## Department of Planning and Zoning

**TO:** Development Review Board  
**FROM:** Scott Gustin & Mary O'Neil, Principal Planners  
**DATE:** June 5, 2018  
**RE:** 18-0834CA/MA; 298 College Street

**Request:** Construct new 2-story, ~50,000 sf YMCA facility including health club and large daycare and related site improvements.

### **Sec. 5.2.7, Density and Intensity of Development Calculations**

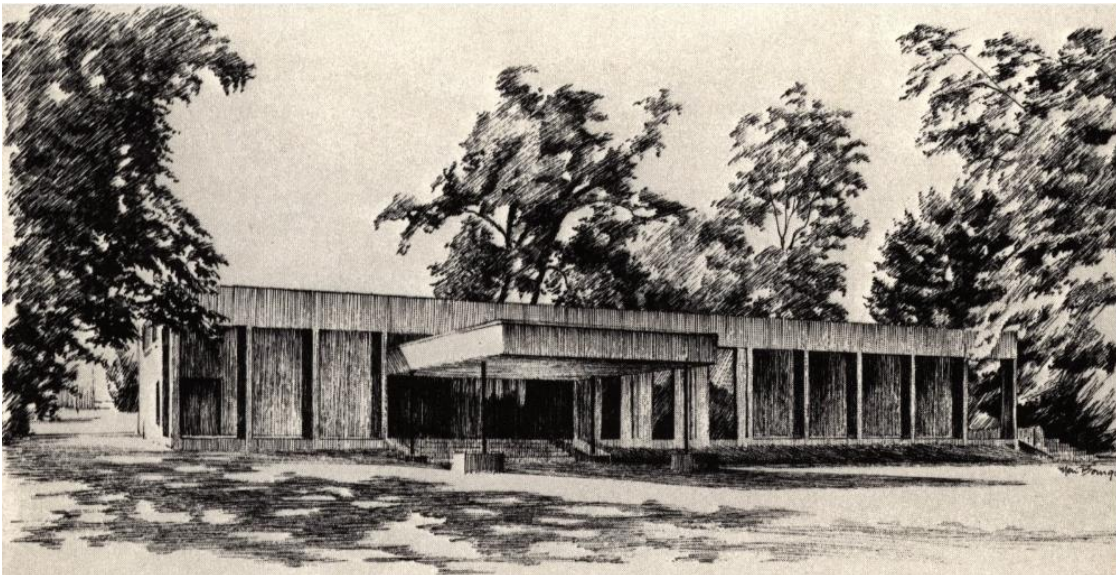
The 51,625 sf facility equates to 34 residential units for the purposes of density calculations in this residential district (every 1,500 sf = 1 dwelling unit). This 1.47 acre parcel could contain up to 58 dwelling units (40 units/acre). The residential equivalency of 34 is acceptable. **(Affirmative finding)**

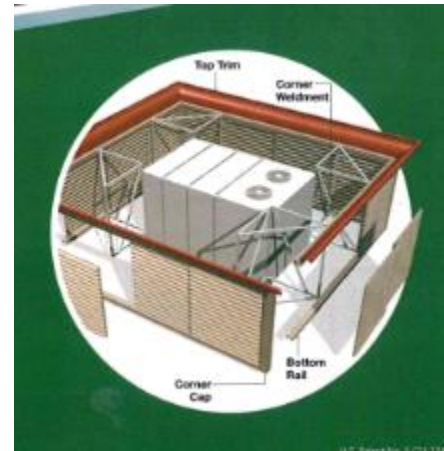
Application materials include specific lighting fixtures and a photometric plan. (See Plan L-200.) The design team notes that Vermont Building Code/NFPA 101 Life Safety requires an identified minimum lighting level along paths for the means of egress from building exits. (1 fc along walking surfaces, no less than 10fc at stairs.) A majority of the walkways onsite are portions of the building's life safety exit discharge and are lit to meet these standards using full cut-off dimmable fixtures.

Section 5.5.2 does offer maximum lighting standards: Parking Lots are not to exceed 4 fc. at any point (achieved); and walkways not more than 2 fc. The walkway immediately east of the building has several "hot spots" under the "W" wallpack fixtures, based on the originally submitted photometric plan. Lowering that illumination would not seem to conflict with NFPA Life Safety standards, and is recommended. Similarly, the "WP" fixtures on the west façade are similarly high, and should be adjusted downward.

A revised photometric, reflecting the lighting plan of L-200 (submitted 5/22/2018) shall be required. **(Affirmative finding as conditioned)**
